**CAMDEN FAMILY HEALTH, INC.
NICHOLAS COUNTY, WEST VIRGINIA**

CAMDEN-ON-GAULEY RICHWOOD CLINIC

ADDENDUM #1

THRASHER PROJECT #060-10260

7 DOOR DETAIL - INTERIOR METAL STUD (PARTITION TYPE 2) - HEAD
A6.01 1 1/2" = 1'-0"

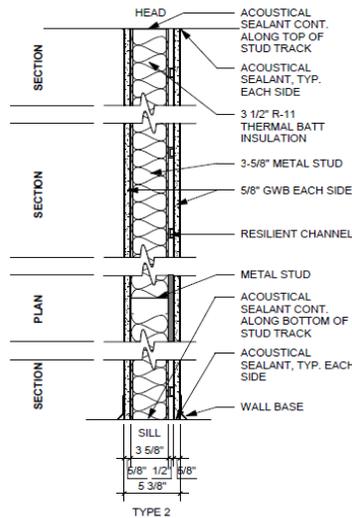
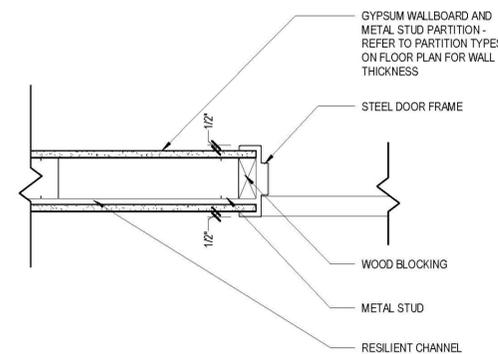
23. Wall Type 2 in coordination with hollow metal door frames.

1. Please provide a head and jamb detail for the hollow metal doors to be installed in wall type 2.
2. Please confirm the frame depth size for hollow metal door frames in wall type 2 is 5-3/4".

- 1) Head and Jamb details for Wall Type 2 shall be provided on Sheet A6.01. The revised Sheet A6.01 is provided with Addendum #1.
- 2) Frame Depth size is approximately 6 - 3/8" for Wall Type 2. The depth is provided in the door schedule on the revised Sheet A6.01 provided in Addendum #1.

4 SLIDING WINDOW DETAIL - INTERIOR METAL STUD - HEAD
A6.01 1 1/2" = 1'-0"

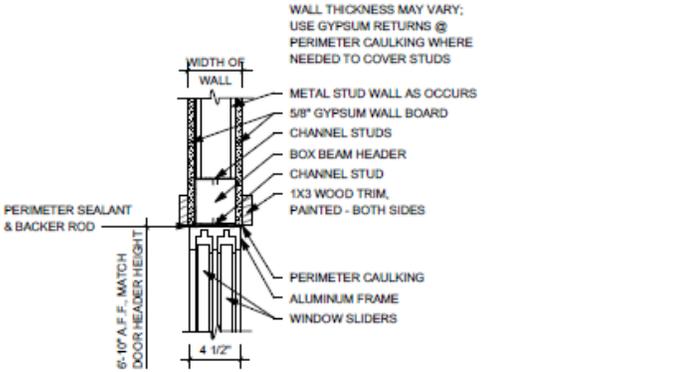
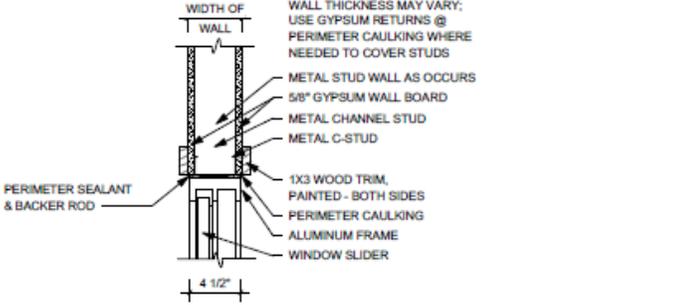
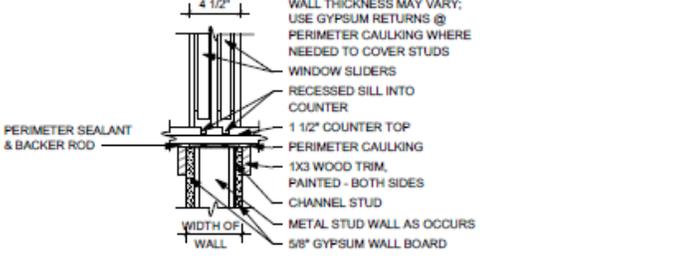
24. Sliding Window Detail - Please provide what species of wood trim is required.
